Access Compliance Report

Public Rights-of-Way

(Curb Ramps)

Intersection ID: 31462	Main Street: JORDANS_POND_LN	Cross Street: SENEY_DR	Location: S
ADA ID: 6B28FC32556F	Ramp Type: PerpDiag	Initial Pass/Fail: Fail	Overall Compliance: No
Severity Score: 8.75			
Codes/Mitigation Info/Possible Solution		Field Measurements/Component Compliance

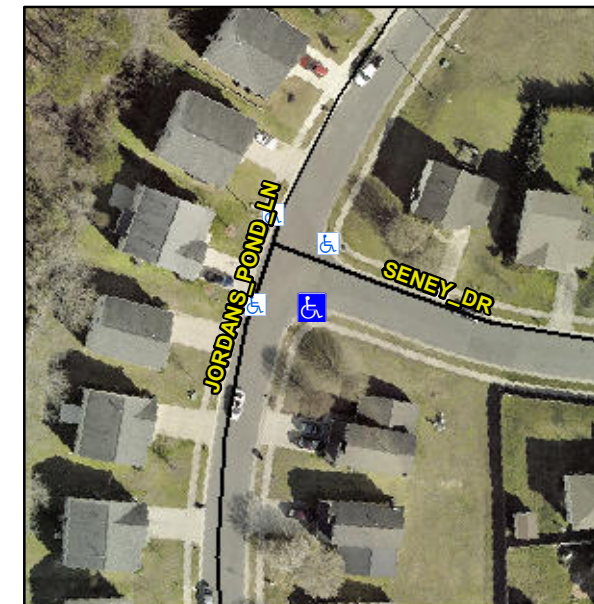
Not Found, R304.5.1

Remove & Replace Curb Ramp With Two New Directional Ramps or Equivalent.
